**SUPPLEMENTARY REPORT TO THE JOINT REGIONAL PLANNING
PANEL
(Sydney East Region)**

JRPP No	2016SYE037
DA Number	16/9
Local Government Area	City of Botany Bay
Proposed Development	Integrated Development Application, requiring approval from the NSW Department of Primary Industries - Water pursuant to the Water Management Act 2000, for a mixed use development containing five buildings of between 7 to 8 storeys. The development comprises two levels of basement car parking, residential apartments, serviced apartments, ground floor retail premises and childcare centre.
Street Address	200 Coward Street, Mascot
Legal Description	Lot 1 DP 701026
Applicant	Karimbla Constructions Services (NSW) Pty Ltd
Owner	Karimbla Properties (No. 36) Pty Ltd
No. of Submissions	Ten (10) in opposition
Regional Development Criteria	Development with a CIV of \$105,959,235
List of All Relevant s79C(1)(a) Matters	• Environmental Planning & Assessment Act 1979, Part 4 – Development Assessment • Environmental Planning & Assessment Regulation 2000, Part 6 – Procedures relating to development applications • State Environmental Planning Policy (Infrastructure) 2007 • State Environmental Planning Policy No. 55 – Cont

Figure 1 Proposed entries to retail and childcare centres with the previous revision shown on the left, and the later amendments shown on the right.

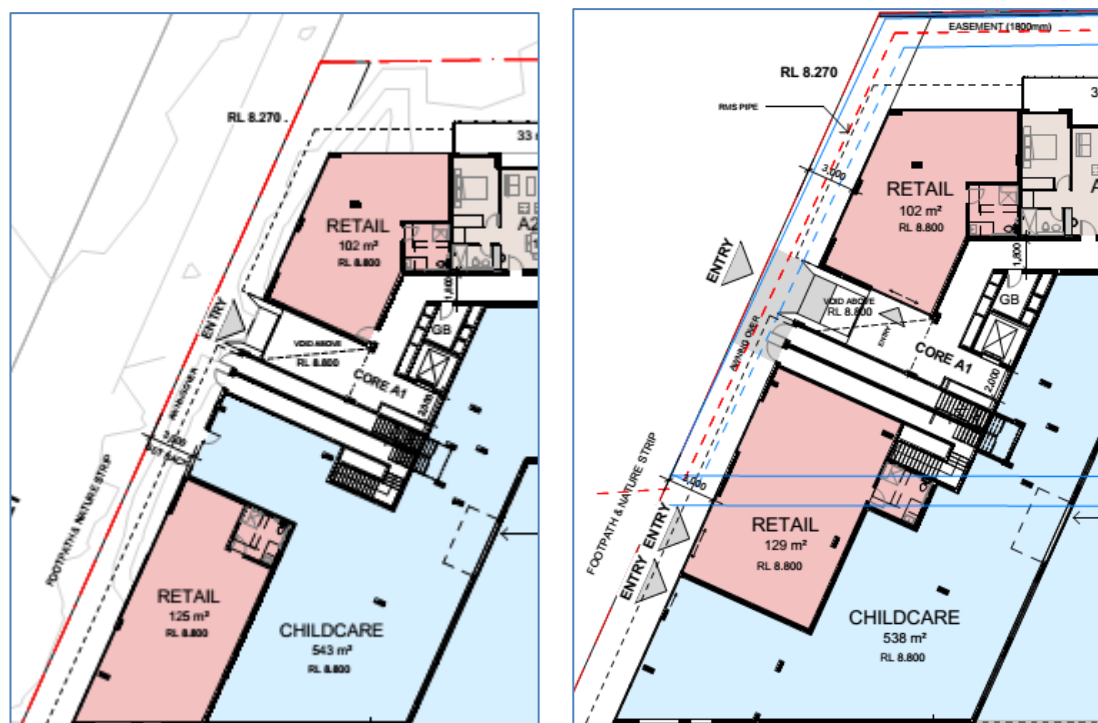
- The proposed ramps would prevent access to the easement for maintenance purposes.
- Information submitted to Council in relation to DA-15/232 indicated that the future RMS easement was not to be strictly for subsurface drainage, but also for overland flow. Although the flood report submitted with the application indicates that there is unlikely to be an overland flow path in this location, the placement of ramps within this location would be contrary to the requirements of the RMS.

An amended ground floor plan was provided with a revised layout of the ground floor retail and childcare centre within Building A. The revised layout provides new entries to the childcare centre and the southern retail premises, both of which sit to the south of the easement drainage pipe. The northern retail premise is provided with a recessed entry, with sufficient space provided to enable a wheelchair lift. The amended architectural and landscape plans are shown below.

Figure 4 Current ground floor plan revision showing entry towards the north has been replaced with an additional bedroom and bathroom.

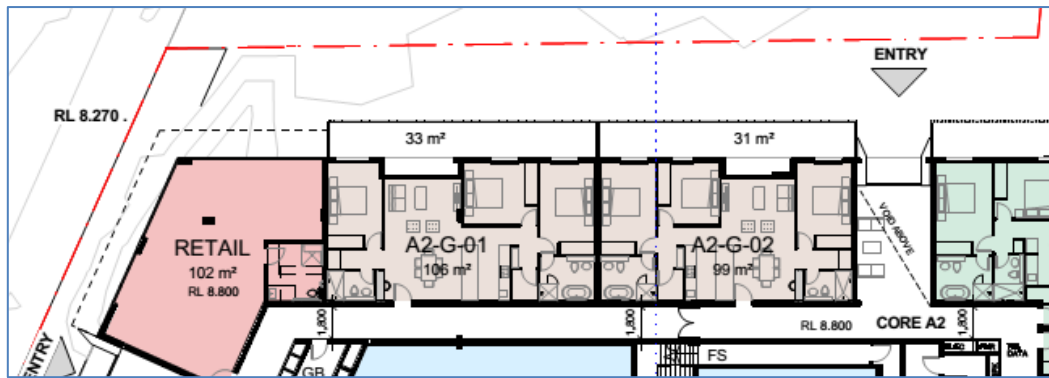
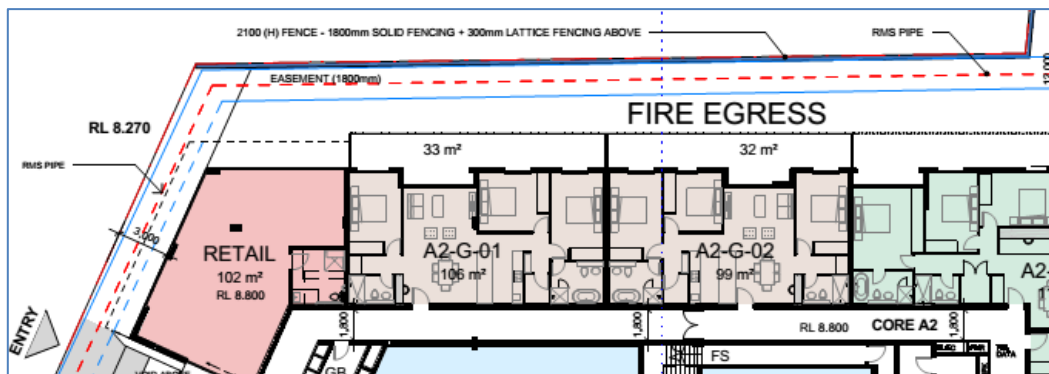
The objector had privacy concerns associated with the northern access point provided in the vicinity of the northern boundary. This area has been provided with a first floor void above, two provide high ceilings at the entry point. The northern entry to Building A has been amended to provide fire egress only, which will require all occupants accessing Building A to enter and exit from the O'Riordan Street entry. The pathway along the northern boundary remains, however, this may require deletion to meet compliance with recommended landscaped conditions, as discussed later within the report.

Note that the deleted lobby has been replaced by the provision of an additional bedroom provided to the adjacent unit, resulting in the conversion of a two bedroom unit into a three bedroom unit. In addition, the first floor void area and a two bedroom apartment, have been replaced by two x one bedroom apartments.

Figure 8 Landscaping provided to the northern boundary, shown in plan.

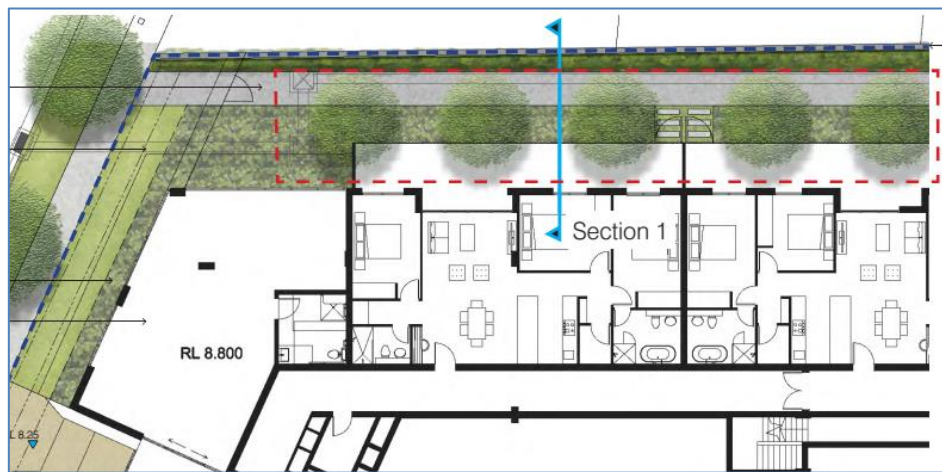
Amended concept landscape plans were provided to Council, which depicted additional landscaping to be provided to the street frontages. However, the plans showed minimal

changes to landscaping provided to screen the development from the north. The following images are provided from the most recent landscape amendment.

Condition 53 (as per the schedule of conditions within the Assessment Report) included a requirement to specifically address landscaping at the northern boundary. This part of this condition relating to the northern screening planting is as follows:

Medium to large trees are to be provided in the northern setback to provide screening and privacy for existing adjoining residential dwellings.

Figure 11 Ground floor GFA plan

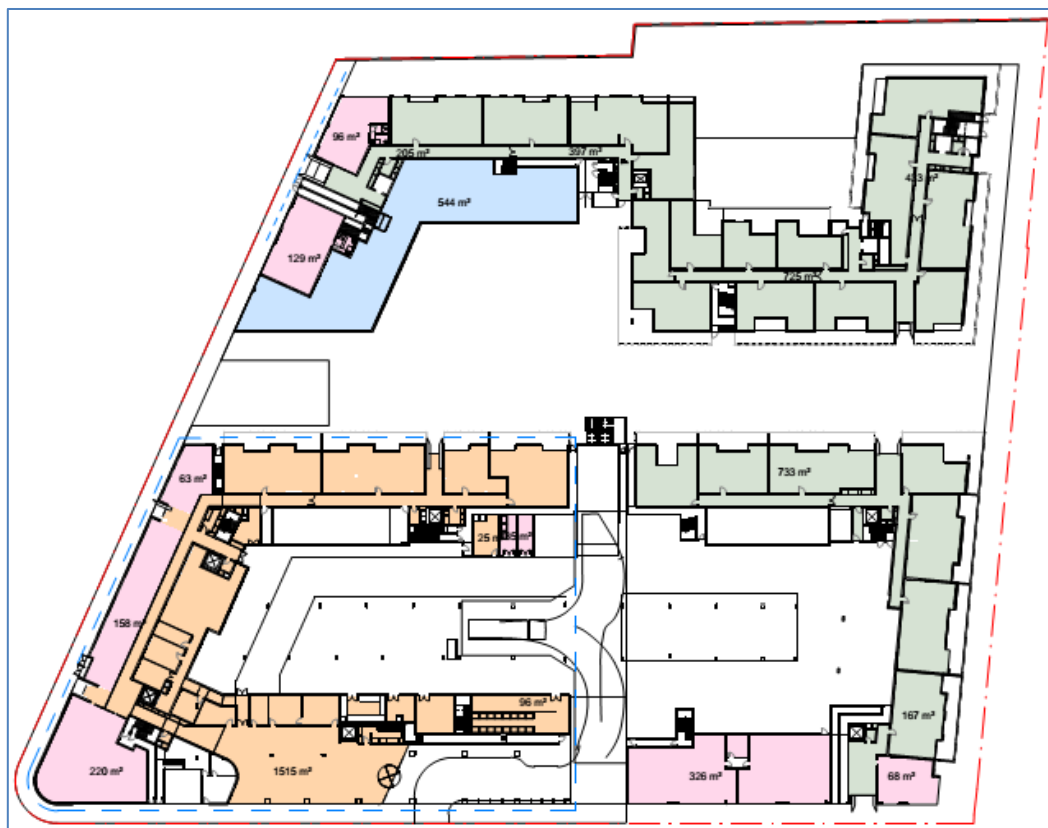
The Panel had raised concerns that areas of the ground floor were not included within the calculation of gross floor area (GFA), and that the proposed floor space ratio may not have been represented accurately.

Updated GFA plans were received which indicate the inclusions for the purposes of calculating GFA. The plans indicate that waste and storage areas were included in the calculation of GFA, and this was consistent with the calculations within the previous plan revision. The GFA plan and Ground Floor Plan are provided below for comparison.

The submitted GFA plans did not include any additional floor space as a consequence of the surplus of parking that is provided at this site. However, Council has reviewed the GFA calculations and the GFA plans, and concluded that additional GFA must be included to account for the surplus of parking.

The GFA of the development, having regard for the inclusions within the GFA plans, is calculated to be 41,488sqm, which gives an FSR of 2.42:1. The dimensions for the parking spaces are given as 2.4m x 5.4m, which equates to 12.96sqm of GFA per additional parking space. The additional floor space generated by the surplus of 84 parking spaces would therefore equate to 1088.64sqm bringing the total GFA to 42576.64sqm, and the FSR to 2.48:1. Therefore FSR will remain compliant with the requirement of 2.5:1.
